**RESOLUTION NO. 2018-16  
LOWER PROVIDENCE TOWNSHIP  
(LPT Project No. LD-16-04)**

**A RESOLUTION OF THE LOWER PROVIDENCE TOWNSHIP BOARD OF  
SUPERVISORS, MONTGOMERY COUNTY, PENNSYLVANIA,  
APPROVING THE PRELIMINARY PLAN OF LAND DEVELOPMENT OF  
ST. JAMES EPISCOPAL CHURCH OUTREACH CENTER LOCATED AT  
3768 GERMANTOWN PIKE, COLLEGEVILLE, PA**

Reference: Land Development  
St. James Episcopal Church

**SUBJECT:** REVIEW COMMENTS – ST. JAMES EPISCOPAL CHURCH OUTREACH CENTER  
LAND DEVELOPMENT PLAN DATED OCTOBER 11, 2017

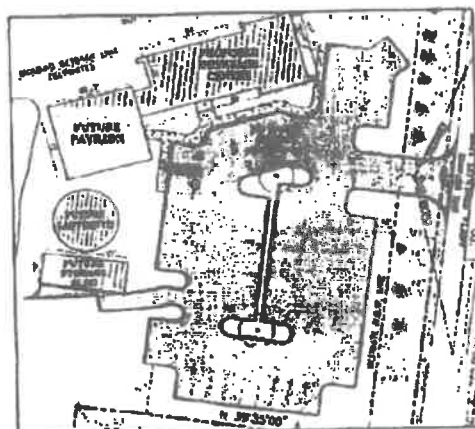
**3. Building Foundation Planting**

Per §123-37.E (SLDO), the area between a building and a parking area shall be used for walkways and foundation planting.

Therefore, a Landscape Plan should indicate plants between the proposed parking and the south side of the proposed Outreach Center building.

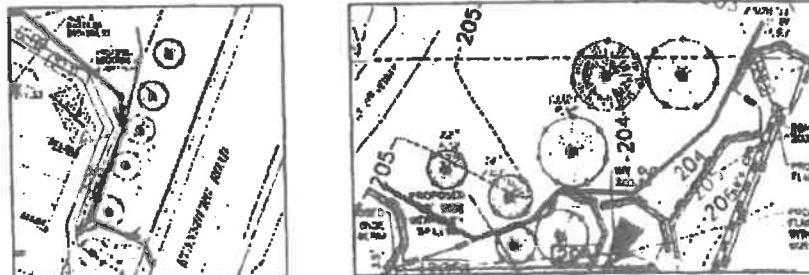
- 6.C In some locations on this property, rather than enclosing individual trees to remain in a circle of fencing, in several locations it would be more efficient and effective to utilize continuous linear sections of fencing to protect several trees together.

For example, to the north of the Evansburg Road entrance, the five (5) Spruce trees are each shown enclosed by an individual circle of fencing. However, a better strategy would be to continuously fence these trees to separate them from disturbance. Another example is along

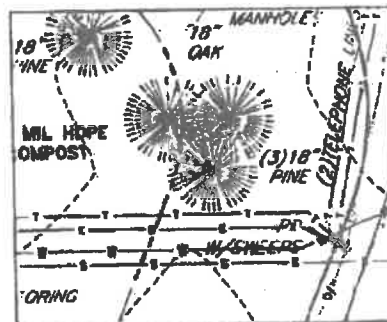
Germantown Pike, where again several Pine trees are individually enclosed. A continuous fence at the Limit of Disturbance line would be more effective.

Utilizing this continuous fence strategy wherever appropriate will reduce the amount of encroachment into the full root zones of the trees, in part by eliminating the likelihood that materials or equipment are stored among the protected trees.

The noted examples are illustrated in the marked Plan excerpts below:

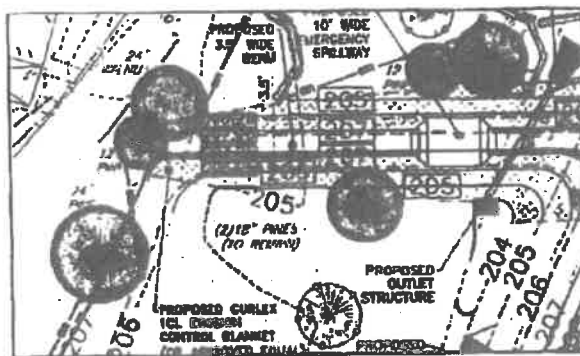
- 6.D As shown in the Plan excerpt below, tree protection fencing will be required for the Pine trees to be preserved adjacent the proposed utility trenches. (The Township Engineer can comment on whether the delineated Limit of Disturbance should encompass these utility lines.)

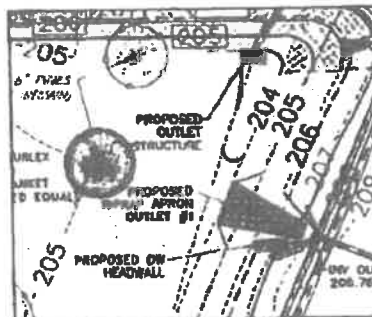
**8. Pine Tree within Basin**

There is a White Pine within the proposed basin area. This area is already a depression fed by a small culvert. However, the new basin will be required to detain a great deal more runoff from impervious surfaces, and this White Pine will be much closer to the new outlet structure than it is from the existing small culvert.

White Pines are very sensitive to flooding. Therefore, the health of this tree could decline rapidly with regular inundation and increased soil moisture. The Applicant could choose to monitor the health of this tree and evaluate if or when it may need to be removed. Alternatively, it could be removed during Land Development. As recommended above, a Certified Arborist may be able to provide greater insight into whether this tree could be successfully preserved within the new basin area.
